FED. ROAD DIST. NO.	STATE	PROJ. NO.	FISCAL YEAR	SHEET NO.	TOTAL SHEETS
HAWAII	HAW.	30A-01-10M	2011	ADD. 2	40

4/21/11	Placed dot on No. D-03, per Addendum No. 1
DATE	REVISION
STATE OF HAWAII DEPARTMENT OF TRANSPORTATION HIGHWAYS DIVISION STANDARD PLANS SUMMARY HONOAPIILANI HIGHWAY RESURFACING Vicinity of Hoohui Road to Plantation Estates Golf Course Project No. 30A-01-10M Date: April, 2009

ADD. 2

ROADWAY PLAN

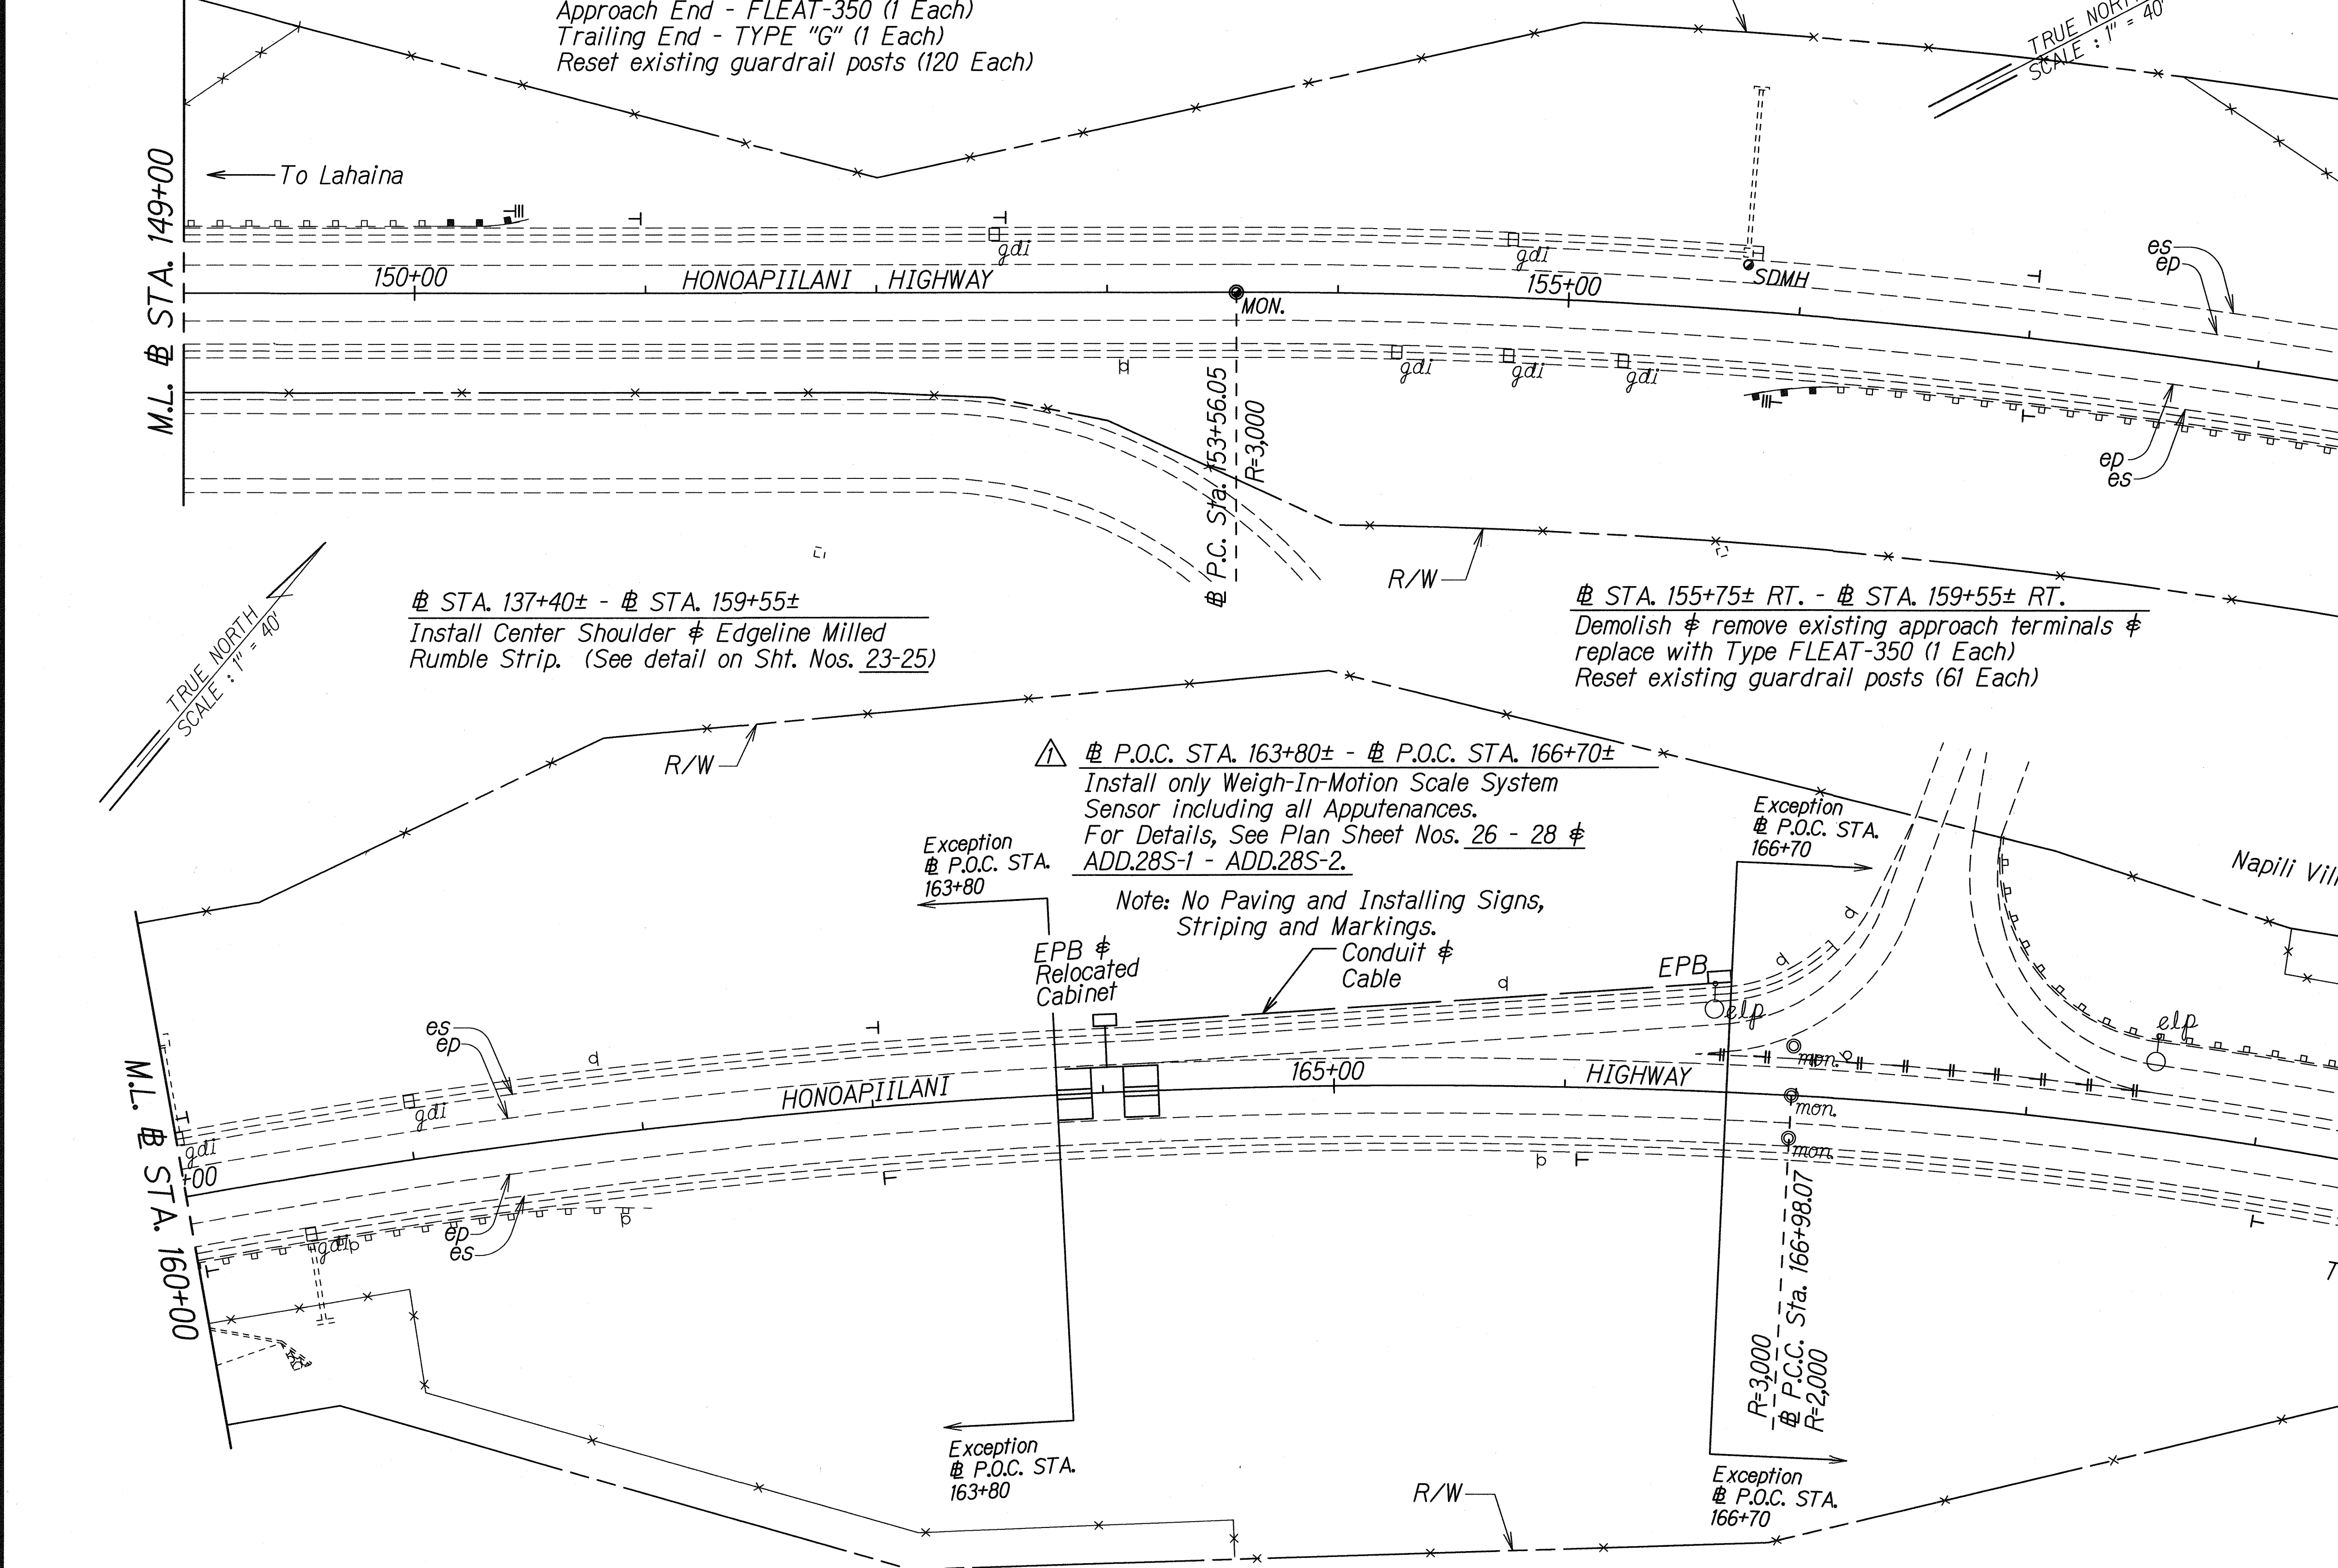
4/21/11	Replaced Note limits to STA. 147+10± to STA. 147+40±, per Addendum No. 1
DATE	REVISION

ROADWAY PLAN

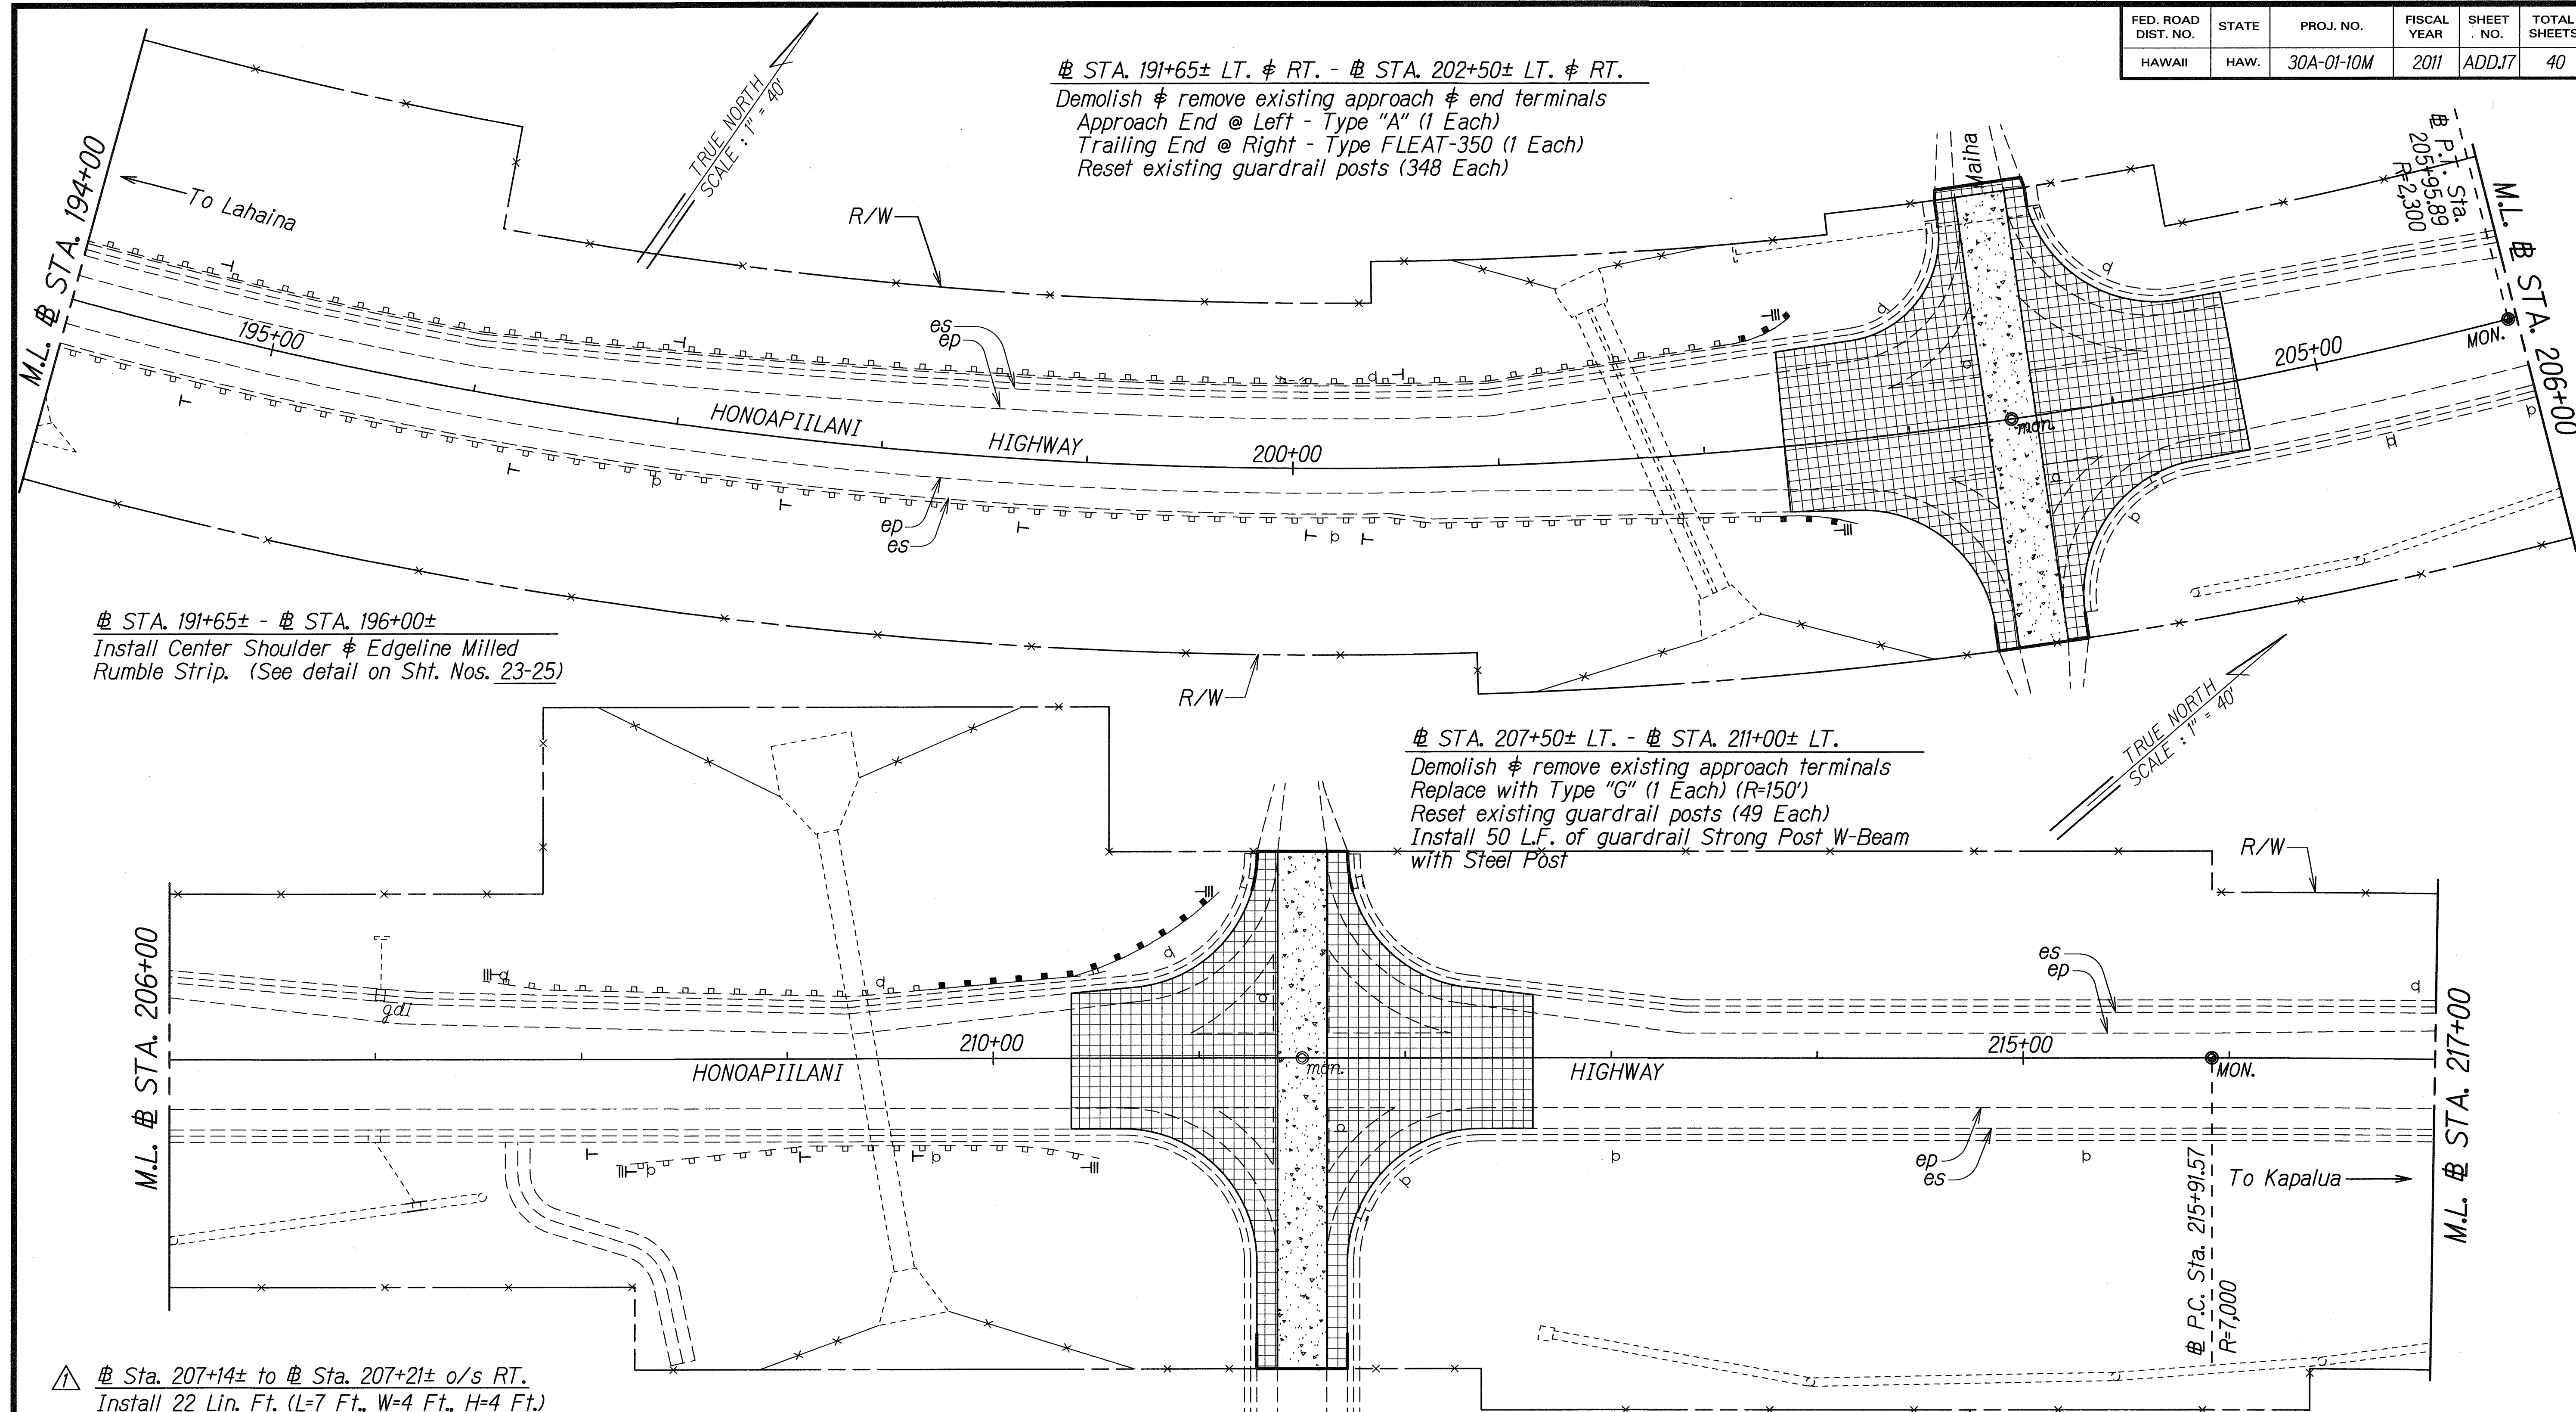
12/16/10	Corrected note.
DATE	REVISION
